PUBLIC UTILITIES COMMISSION

Wildfire Safety Division's Revision Notice for Pacific Gas & Electric Company's 2021 Wildfire Mitigation Plan Update

Figure 1: PG&E’s Reported VM Territory Cycle Expenditure

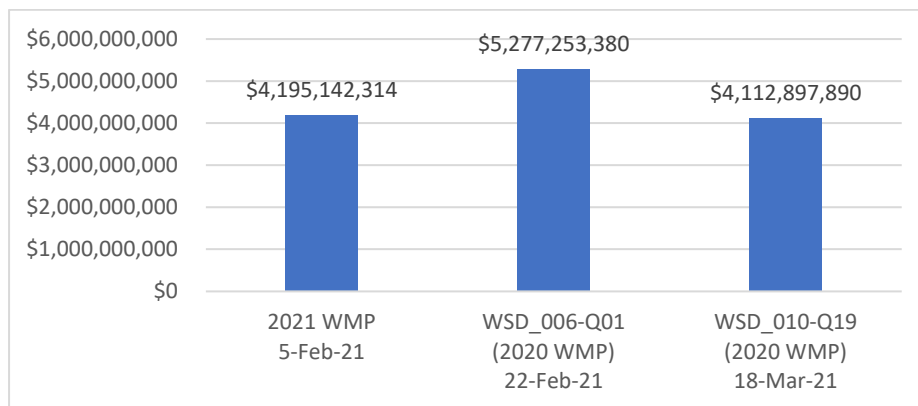
\$5,277,253,380,⁴⁷ and the VM HFTD Cycle expenditure was \$2,593,528,635.⁴⁸ The VM HFTD Cycle expenditure matches expenditure reported in PG&E’s First Quarterly report. However, VM Territory Cycle expenditure is reduced by \$1,082,111,066 relative to the 2021 WMP (see Figure 1).

On March 18, 2021, PG&E submitted “WildfireMitigationPlans_DR_WSD_010-Q19Atch01.xlsx” in response to DR WSD_010-Q19. In this response, PG&E reported the 2020 WMP VM Territory Cycle expenditure (as initially asked in WSD_006-Q01) as \$4,112,897,890.⁴⁹ This value is \$1,164,355,491 less than previously reported in PG&E’s response to WSD_006-Q01; *the WSD expects these figures to be the same, or very similar*. Variation in the VM Territory Cycle expenditure is illustrated by Figure 1.

Critical Issue No.	Critical Issue Title	Required Remedies
PGE-05	Unresolved Discrepancies in Vegetation Management Expenditure Data and their Effect on the Entire WMP	<ol style="list-style-type: none"> 1. PG&E shall submit a revised Table 12 in the format of the attached Excel file named “PG&E Revision Table 12 Template.xlsx.” This includes: <ol style="list-style-type: none"> a. Annual expenditure, split by capital expenditure and operating expenditure, for each WMP initiative in HFTD and in its total territory (HFTD + non-HFTD), as forecasted in 2020 and reported in 2021; b. Columns K-AB require 2020 WMP forecasted expenditure for the 2020-2022 WMP cycle; c. Columns AC-AT require 2021 WMP Update forecasted expenditure for the 2020-2022 WMP cycle (actual expenditure for 2020 + forecasted expenditure for 2021 and 2022). 2. PG&E shall explain in full and complete detail why the expenditure information in WSD-006-Q01 is so drastically different from previous submissions. 3. PG&E shall explain in full and complete detail what quality controls it has in place to ensure accurate and consistent reporting of expenditure. 4. PG&E shall explain in full and complete detail how it will ensure accuracy and consistency of the information contained within its future WMP submissions (particularly in relation to expenditure) going forward.

Figure 2: PG&E's 2020 Reported WMP VM HFTD Cycle Expenditure

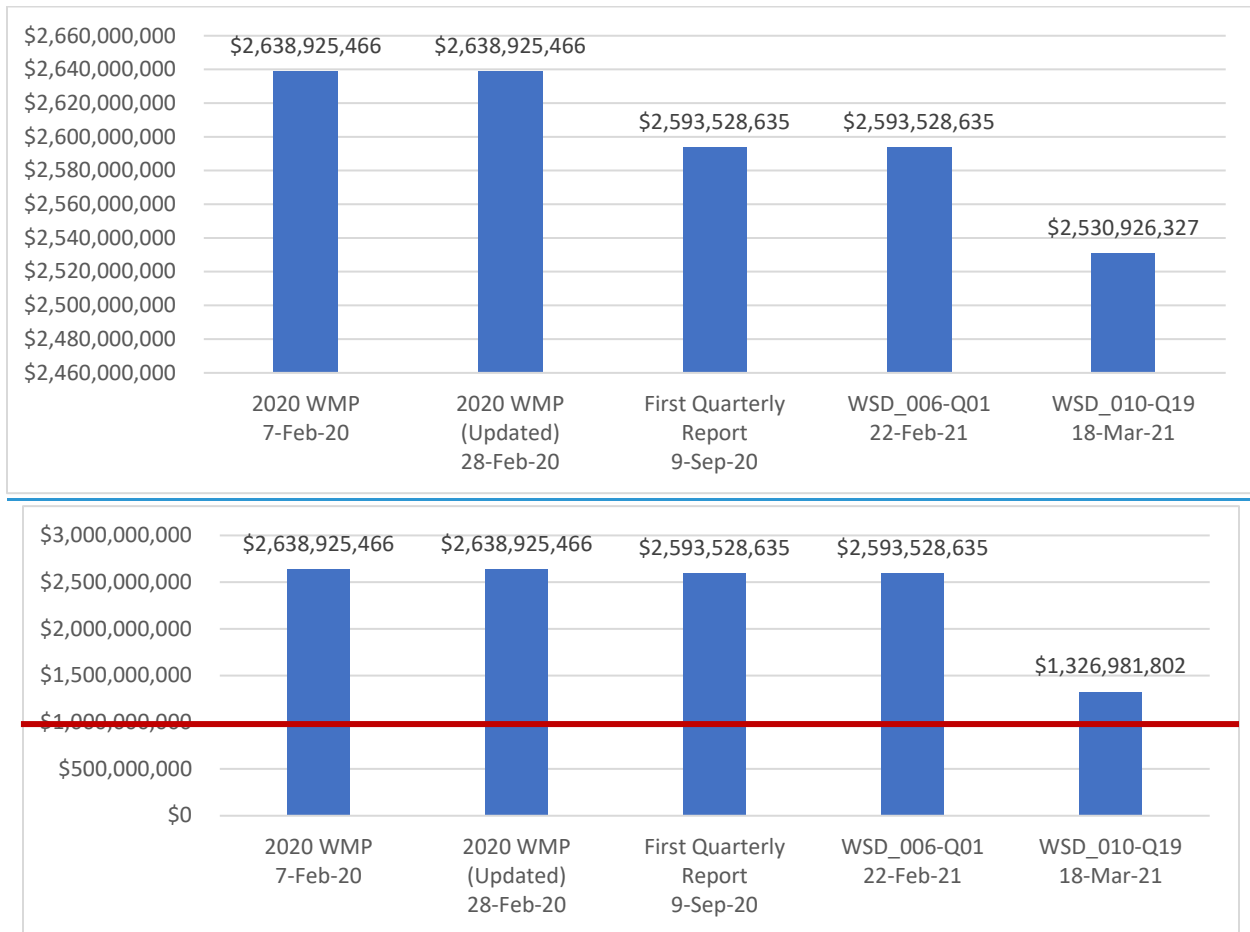
Similarly, in response to WSD_010-Q19, PG&E reported the 2020 WMP VM HFTD Cycle expenditure as ~~\$2,530,926,327~~ ~~\$1,326,981,802~~.⁵⁰ This value is ~~\$62,602,308~~ ~~\$1,266,546,833~~ less than previously reported in PG&E’s response to WSD_006-Q01 and less than every other prior submission mentioned in this analysis: *these figures should be the same*. Variation in the 2020 WMP VM HFTD Cycle expenditure is illustrated by Figure 2.

PG&E previously explained the difference in HFTD forecasted expenditure (Figure 2) between the 2020 WMP and the First Quarterly Report/ WSD_006-Q01 in its response to Condition Guidance-5 (Class B) from Resolution WSD-002. The response to Condition Guidance-5 and explanation of the “updated spend” can be found in PG&E’s First Quarterly Report.⁵¹ In the “Wildfire Safety Division Evaluation of Pacific Gas and Electric Company’s First Quarterly Report,” published January 8, 2021, the WSD found PG&E’s response to Condition Guidance-5 to be Sufficient.⁵²

The new values submitted on March 18, 2021 as part of its response to DR WSD_010-Q19 have not yet been justified by PG&E.
